SERVICETEKNOTES

TABLE OF CONTENTS

1807 FIGURE 2 MANUAL CORRECTION

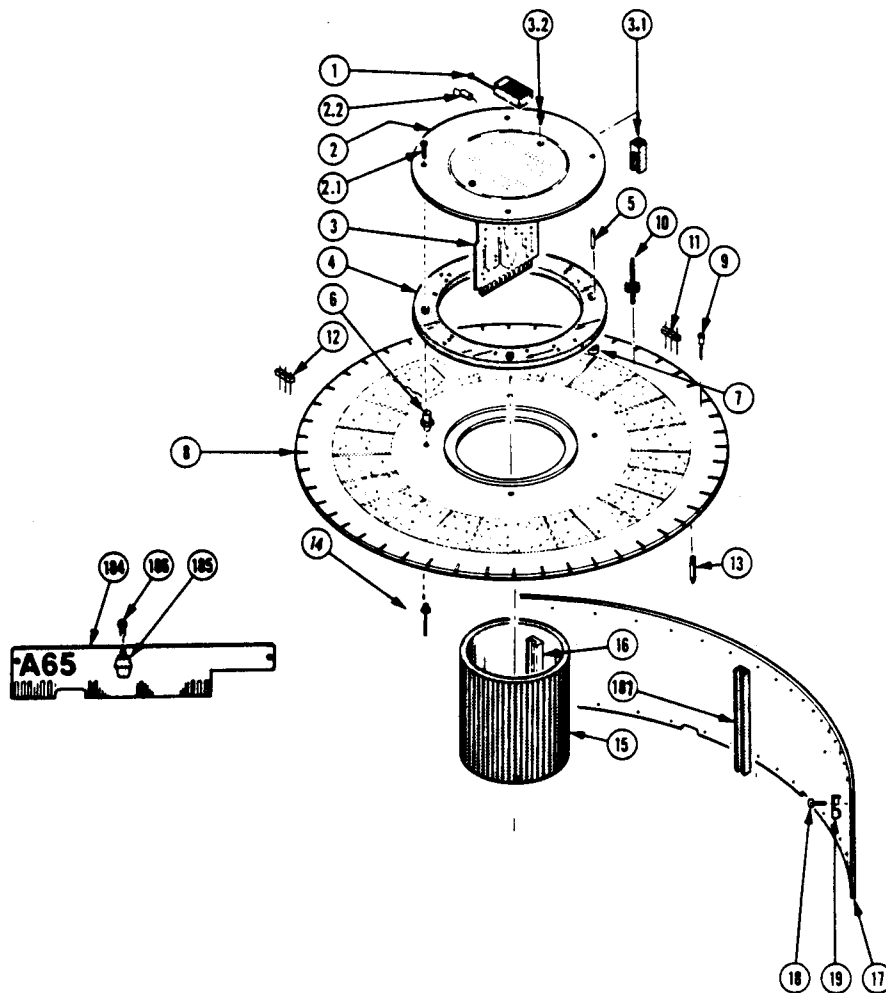
In the 1807 manual, Volume 2, 070-4134-00, page 6-77 there are errors. The load board and hardware Fig. 2 index numbers 3 through 14 are incorrect. Shown below is the correct mechanical view of the load board and hardware plus the corrected part number listing.

-2.1 214-1878-00	4 THUMBSCREW:4-40 X 0.48,0.5 DIA,SST	80009 214-1878-00
	(EACH CKT BD CONTAINS)	
-2.2 131-0566-00	64 . BUS CONDUCTOR:CKT CD,12 FEM,PH BRZ	80009 131-0556-00
-3 020-0080-00	1 ACCESS.KIT,TEST:UNDERSOCKET ASSY	80009 020-0080-00
-----	- (SEE STANDARD ACCESSORIES)	
-3.1 352-0139-01	2 . HOLDER,CKT CARD:	80009 352-0139-01
	(ATTACHING PARTS)	
-3.2 211-0119-00	2 . SCREW,MACHINE:4-40X0.25" 100 DEG,FLH,STL	83385 OBD

-4 354-0533-01	1 . RING,ELEC CONT:W/CONTACTS	80009 354-0533-01
-5 131-1699-00	188 . CONTACT,ELEC:POGO SPR LOADED	80009 131-1699-00
-6 129-0428-02	4 . SPACER,POST:0.45 L,2/4-40 THD THRU,0.25 HEX	80009 129-0428-02
-7 354-0541-00	2 . RING,SECURING:0.0781 ID X 0.188 OD,NYLON	80009 354-0541-00
-8 670-2831-XX	1 CKT BOARD ASSY:DC LOAD	
-----	- (SEE STANDARD ACCESSORIES)	
-9 131-1720-00	384 . CONTACT,ELEC:FEM RCPT TO SPR CONT,POGO	80009 131-1720-00
-10 131-0589-00	1298 . TERM,PIN:0.46 L X 0.025 SQ,PH BRZ GL	22526 47350
-11 131-1343-00	2 . TERM. SET,PIN:36-0.525 L X 0.025 SQ	22526 65501-136
-12 131-1614-00	40 . CONTACT ASSY,EL:	22526 65502-136
-13 386-1559-00	4 . SPACER,CKT BD:0.47 H,ACETAL	80009 386-1559-00
-14 131-1401-03	4 . CONTACT,ELEC:RMT OR LOAD TO SCTR,GOLD PLTD	80009 131-1401-03

GROUND IMPROVEMENT

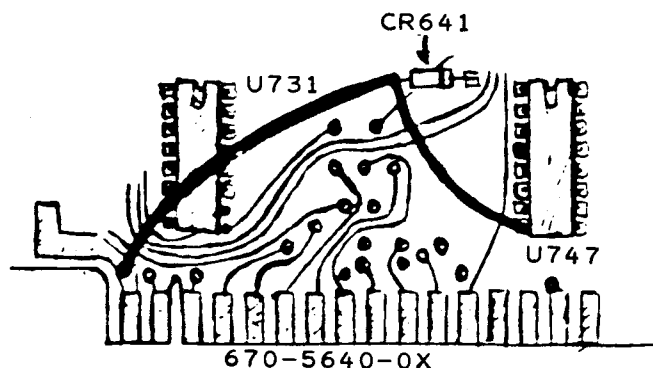
The cause of this phenomenon has been traced to noise on the Display Control boards, 670-5640-02 and below. The final fix will be a layout change to the ECB which will add a ground plane and a +5 volt plane. On the current boards there are only runs for these functions.

The manufacturing line has been hand adding number 26 gauge wire in strategic points to better ground out the noise. This is not considered a modification because the ground runs are already there. Also the revision level of the board does not change.

The wire is added from Buss pin 72 to the anode of CR641 and to U747 pin 8 as shown in the drawing.
